MEMORANDUM

Subject: Responses to Comments on the SCEA for the
5001 Wilshire Project

Date: August 8, 2022

Throughout the 50 separate documents posted on line today, there are 2 references to Transformer Location. They are on:
Figure II-4: Project Plot Plan
Figure II-25: Conceptual Greenbelt Plan

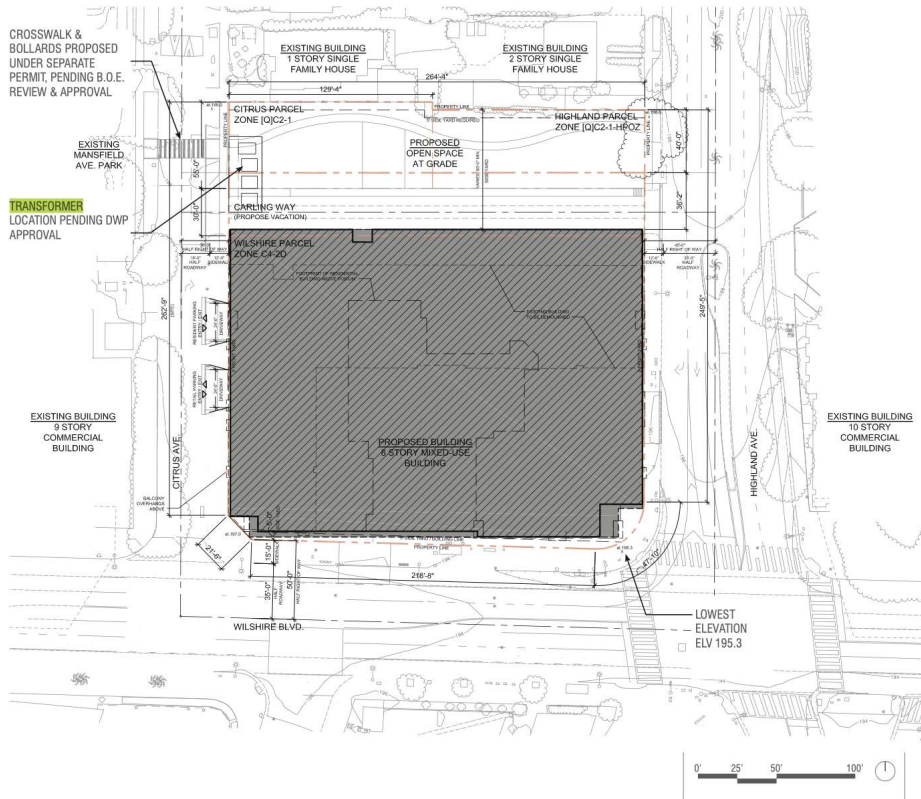
As you can see from the two figures referenced above there are differences in (1) the number of transformers/switches (3 and 4) and (2) the location of the transformers (on the concrete paved walkway and not on the walkway).

This was an important issue to many of the adjacent residents and brought to the City's Planning Department attention early in the process. This was also discussed with the developer's team 2021.
